Access Compliance Report

Public Rights-of-Way

(Curb Ramps)

| Intersection ID: 6114 | Main Street: ATKINS_RIDGE_DR | Cross Street: HARTLEY_HILLS_DR | Location: S |

| ADA ID: B4D992012DAD | Ramp Type: Perp | Initial Pass/Fail: Fail | Overall Compliance: No |

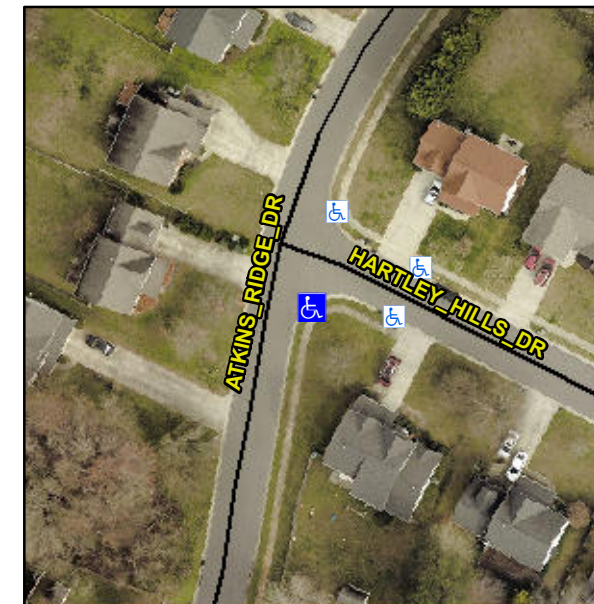
R304.2.2, R304.5.3

| Compliance | Description | Data | Compliance | Description | Data |
|------------|-----------------------|-------|------------|-----------------------------|------|
| N/A | Ramp Length (in) | 48.0 | No | Ramp Slope (%) | 10.0 |
| Yes | Ramp Width (in) | 48.0 | No | Ramp XSlope (%) | 6.2 |

Remove & Replace Entire Ramp.
